**SOIL, GEOLOGY, GEOLOGIC HAZARD STUDY
EAGLE RISING
PARCEL NOS. 52290-00-034 AND 52290-00-035
EL PASO COUNTY, COLORADO**

Add PCD File #
SF-22-025

Update report throughout
to coincide with current
proposed plat and
subdivision plan see
comments and pg 25

DEVELOPMENT PLAN / TEST BORING
 LOCATION MAP
 SEAGLE RISING
 EL PASO COUNTY, COLORADO, CO.
 FOR: CASAS LIMITED PARTNERSHIP #4

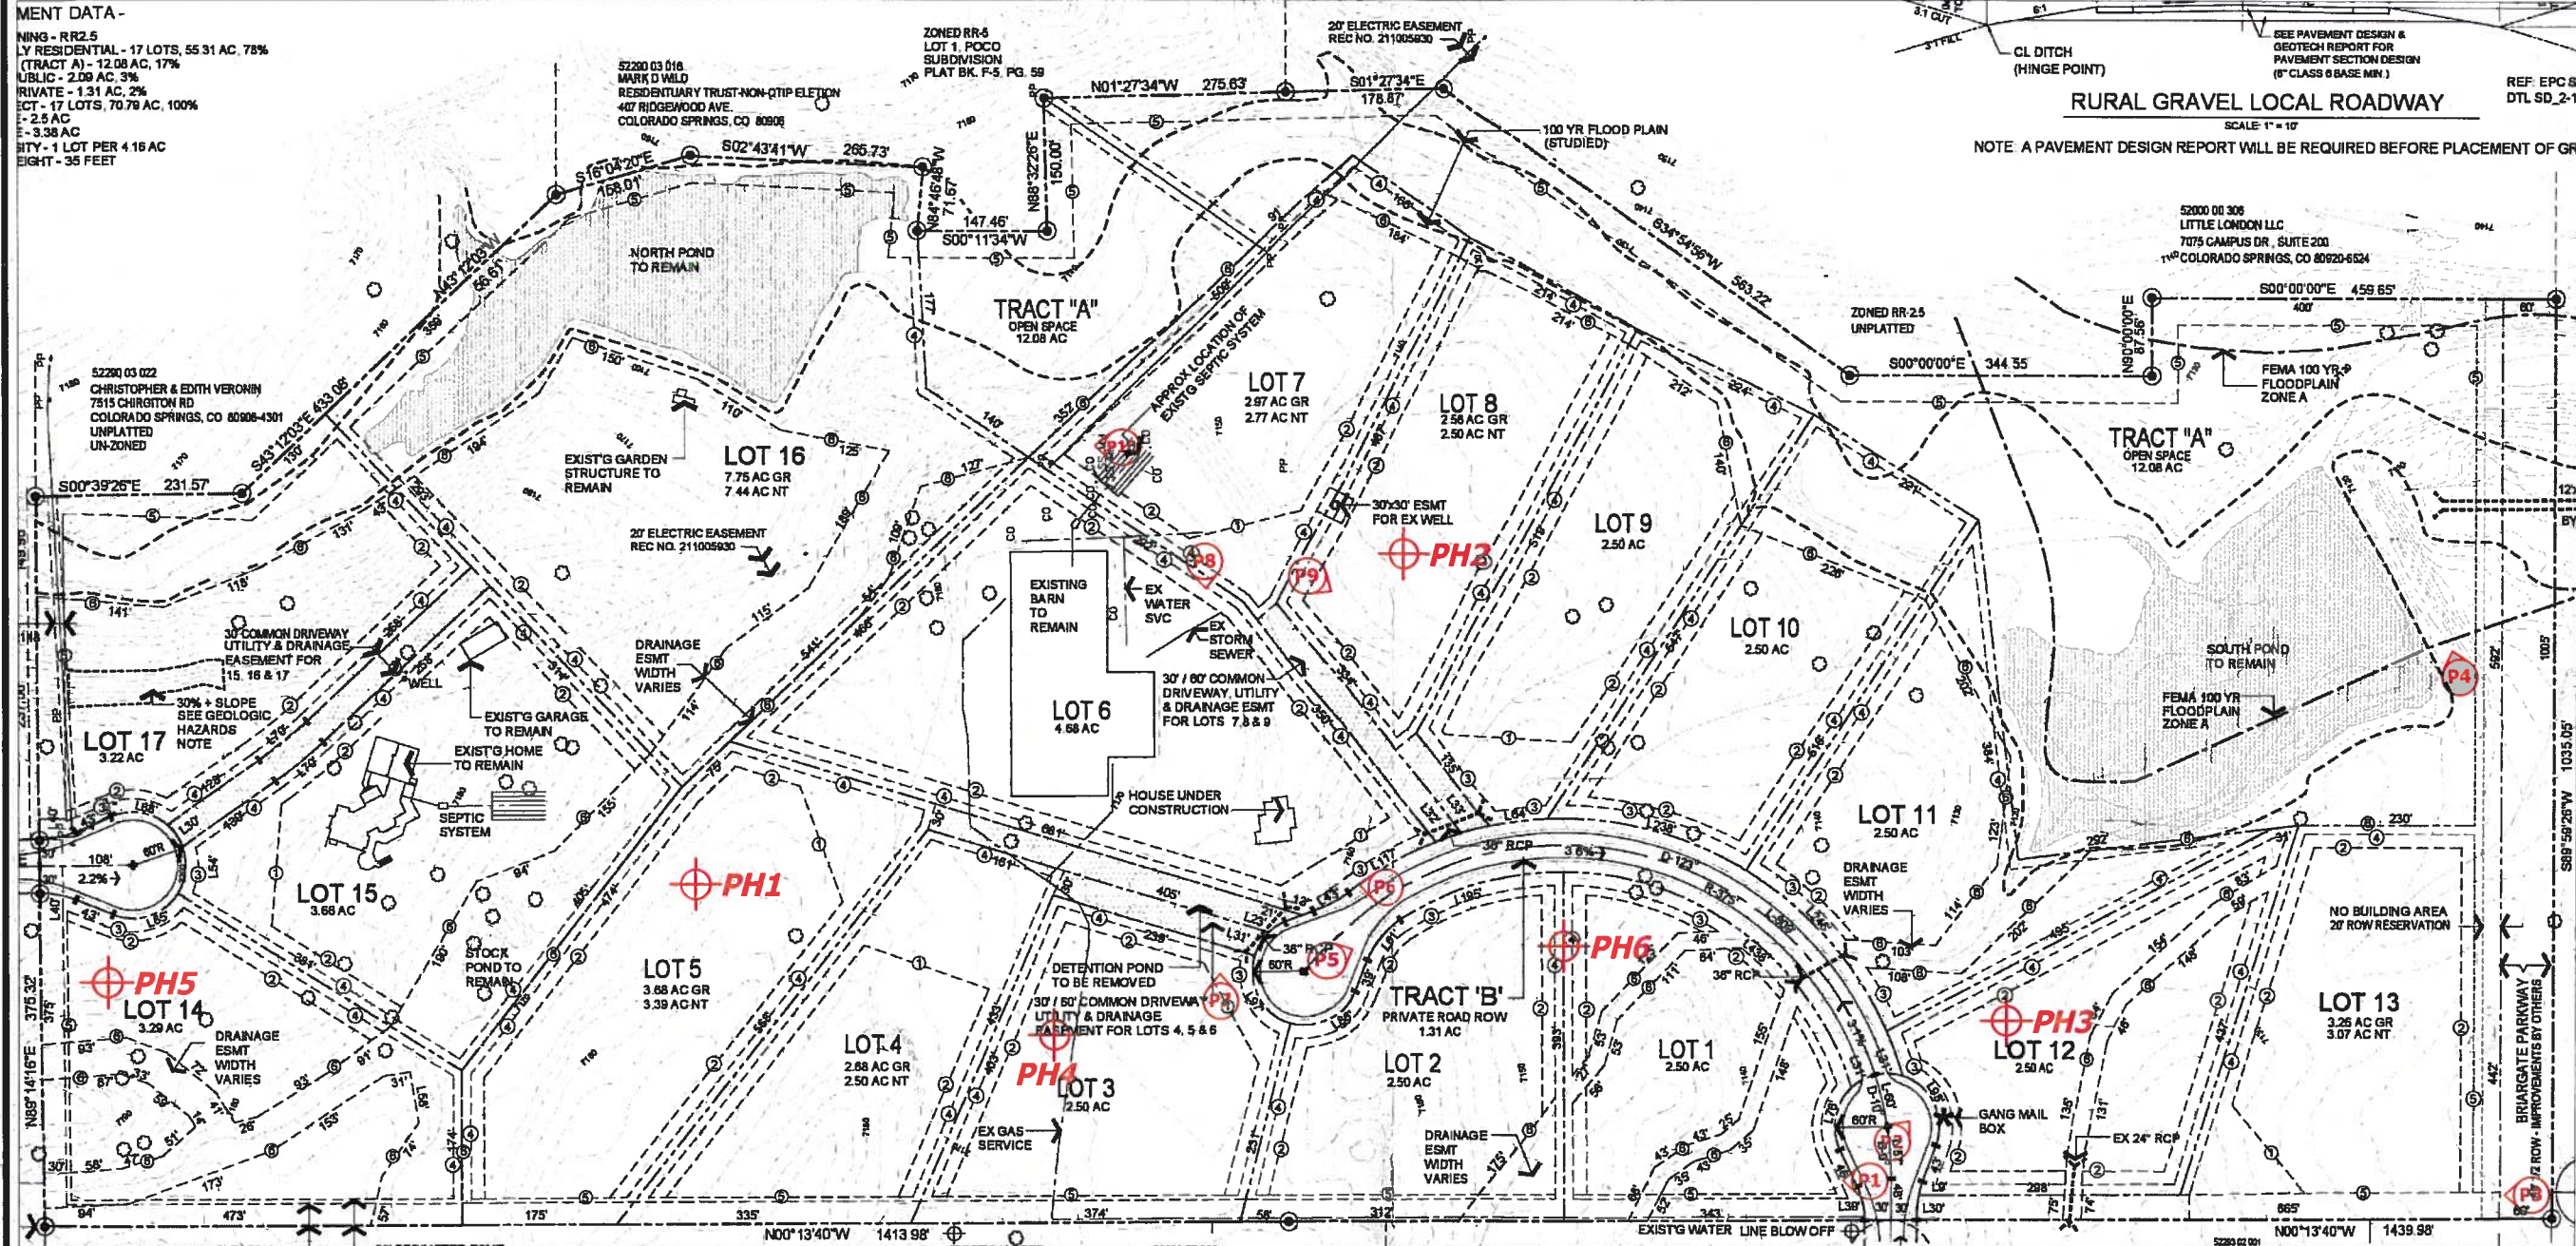
Replace with current proposed Plat and subdivision plan and align test points
